RECALL CAMPAIGN BULLETIN

NTB10-031

VOLUNTARY SAFETY RECALL CAMPAIGN 2006 AND 2008 FRONTIER, XTERRA, PATHFINDER FUEL GAUGE INACCURACY

CAMPAIGN ID #: PC042
NHTSA #: 10V-075
APPLIED VEHICLES: 2006 and 2008 Frontier (D40)
2006 and 2008 Xterra (N50)
2006 and 2008 Pathfinder (R51)

Figure 3

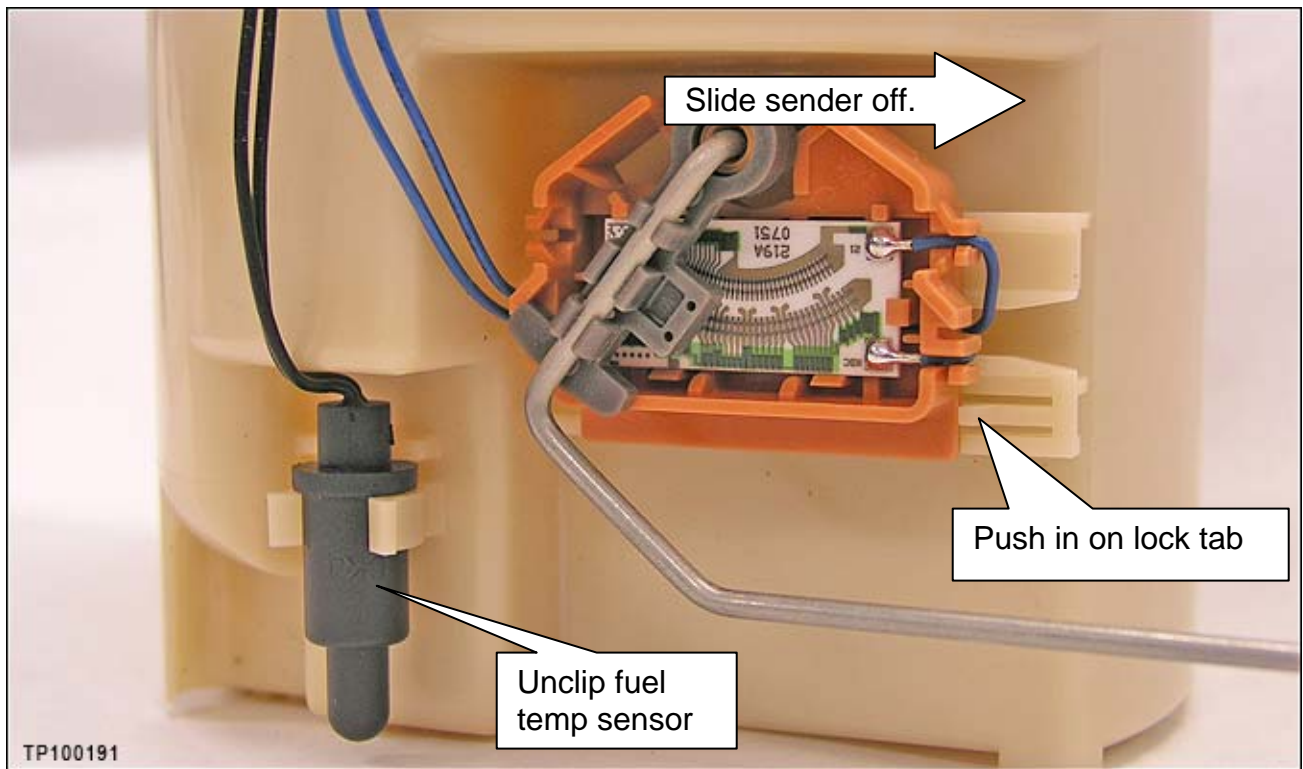
4. Remove the fuel gauge sender unit from the fuel pump assembly as follows:
 - a. Press in on the lock tab.
 - b. Slide the sender unit off.
 - c. Unclip the fuel temperature sensor.

Figure 4

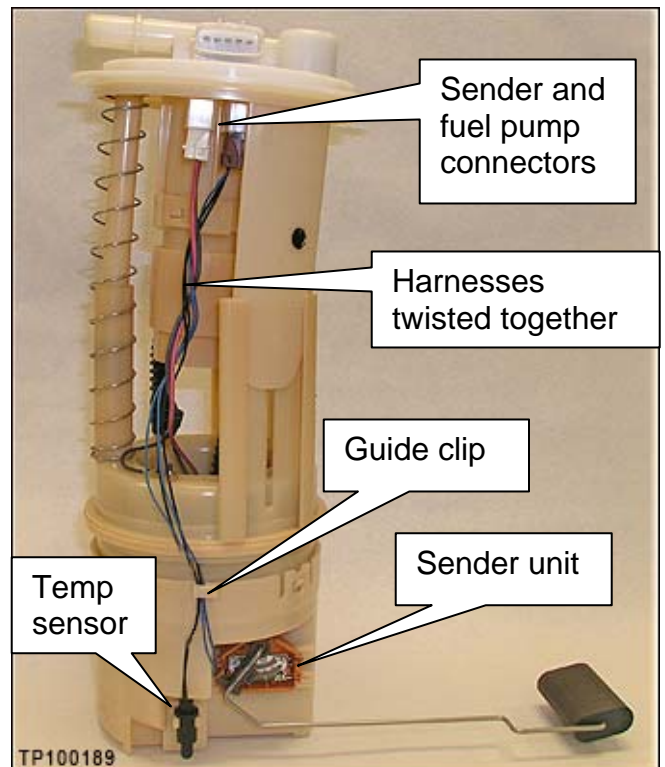
5. Install the new fuel level sender unit in reverse order.

- Sender connector and fuel pump connector are securely connected.
- Fuel pump harness and sender harness are wrapped / twisted together.
- Sender and temp sensor wires are inside guide clip.
- Sender unit is locked in place.
- Temp sensor is clipped in place.

CAUTION: Do not bend the float arm when handling the new fuel gauge sender unit.
